Vacuum Cabling and Feedthroughs Requirements

Action Items from DRR

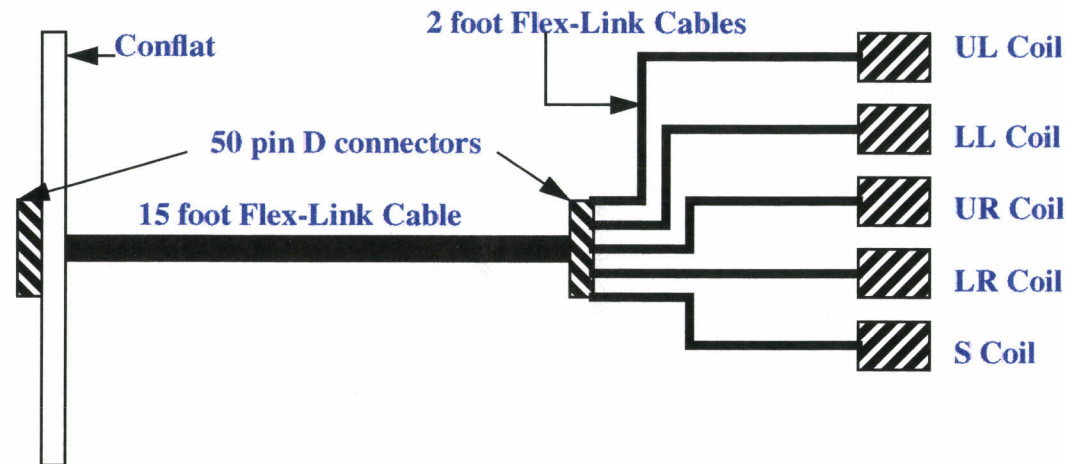
- Concern: Possible “crackling” of kapton wiring.

››Response: Prototype cables have been procured and will be tested. Initial testing with samples indicates that crackling only occurs if the cable is twisted. Testing will be difficult without a seismic isolation test stand, but we should be able to test as part of the 40 meter installation.
